CITY OF CONWAY, ARKANSAS HISTORIC DISTRICT COMMISSION

1824 Lee Ave - Exterior Modifications

Old Conway Design Overlay District

II.A

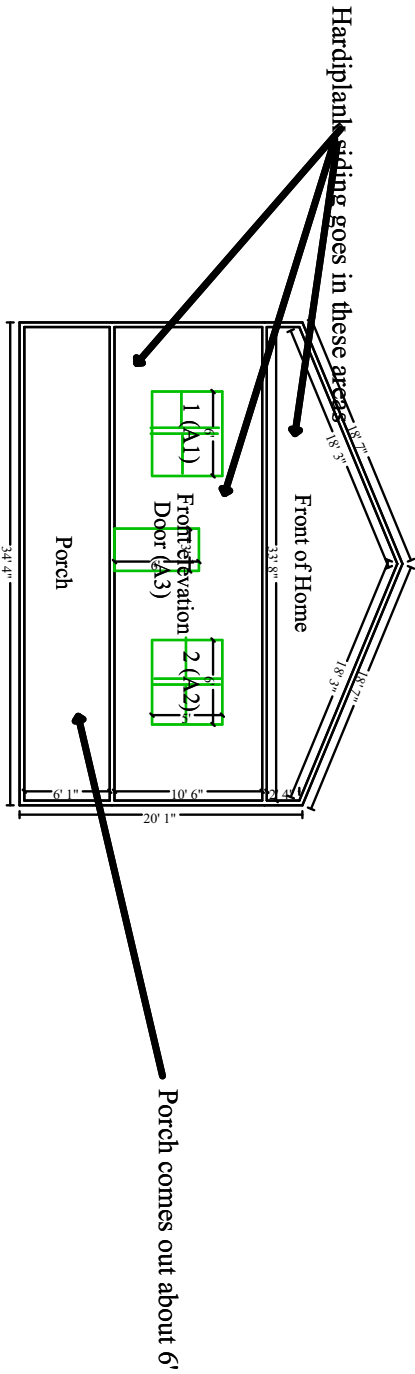
Entries, Porches, and Porticos, Doors and windows, Awnings. Porches are encouraged and should be at least 6' deep, when present. Entries should contain special decorative elements and ornamentation. Windows should be of divided-light construction, where divided-light windows are proposed. Fake muntin bars are not permitted.
*According to the applicant: "We are expanding the front windows from a single 2'3"x4" window to 2 double 3"x5" windows which will create 2 6"x5" openings. They will be symmetrical to the home and trimmed with 4" trim around."
*The applicant is proposing wide-trim, and the double windows will be in conformance with the standards.**

Architectural Details, Siding, and Bricks. Detailing and siding should complement the surrounding area. Siding should include brick, stone, wood, or Hardie® siding/LP® SmartSide®
The applicant is proposing Hardie® siding to "further restore the original look of the home." The current siding is metal/vinyl. Hardiboard is preferable to metal/vinyl.

1. Applicant must obtain all applicable building permits* if/when a Certificate of Appropriateness is granted.
**Applicant shall provide proof of appropriate licensure of professionals performing work to the Building Permits Department.*
2. Windows must be true divided light.
3. If shutters are used, they must be sized to fit the windows.
4. Siding may be wood, brick, or Hardie® siding/LP® SmartSide®.

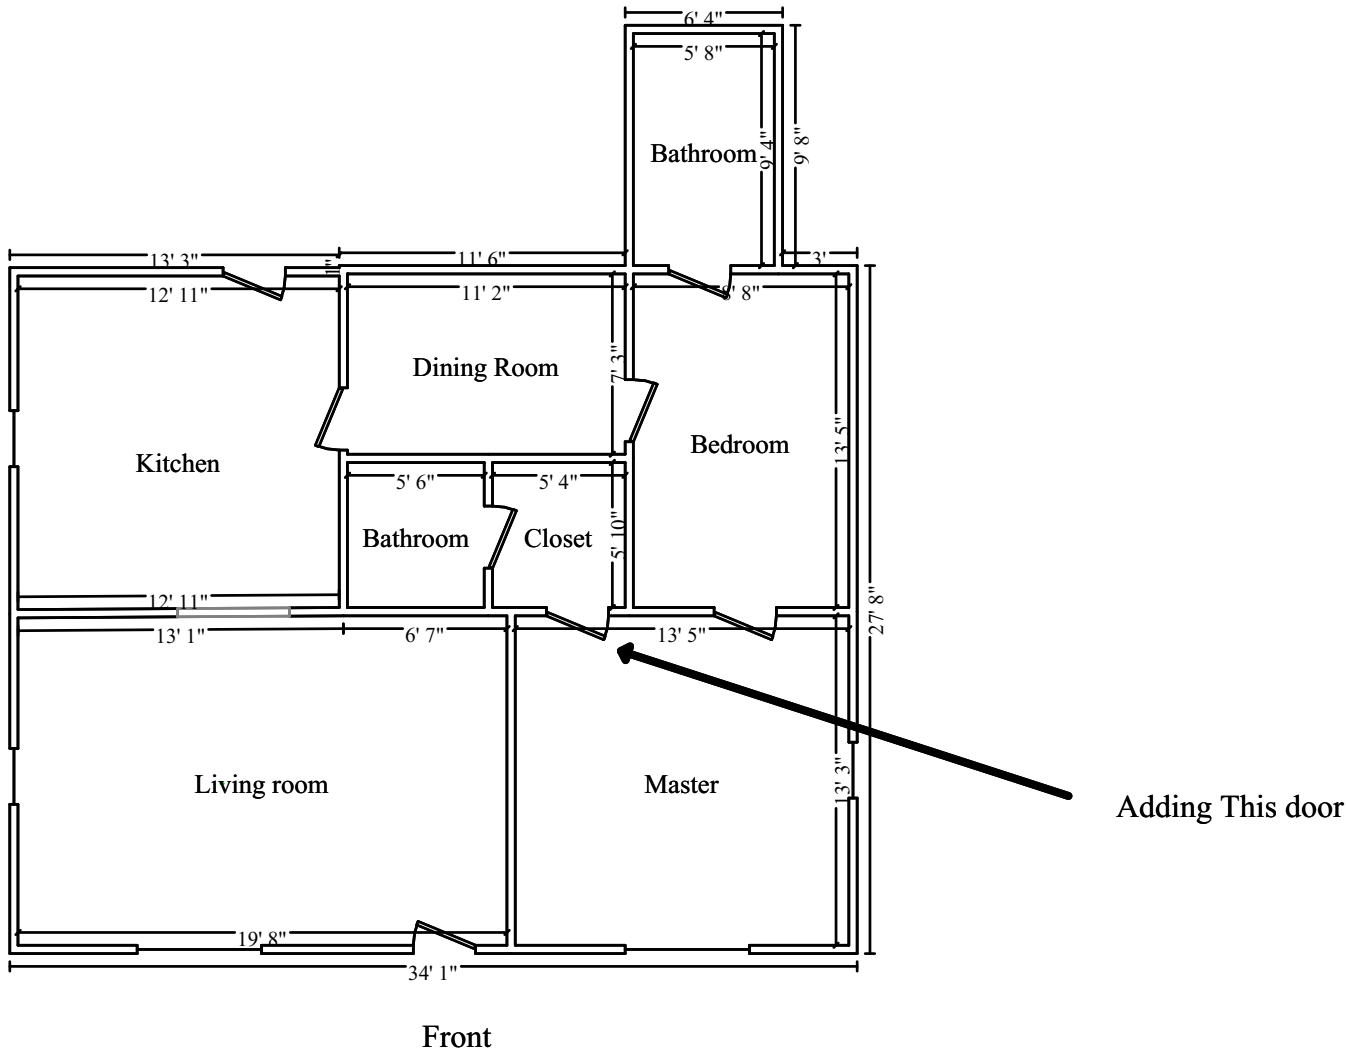
Windows are a gridded white vinyl window I am attaching a rough sketch as well as a page from the manufacturer. they will have Low E glass and High e

Expanding existing 2'3x4' windows with 2 double 3'x5' windows and have decided to not add shutters at this timeto the outside of them. We will also add concrete lap siding to the front with white paint to replace vinyl
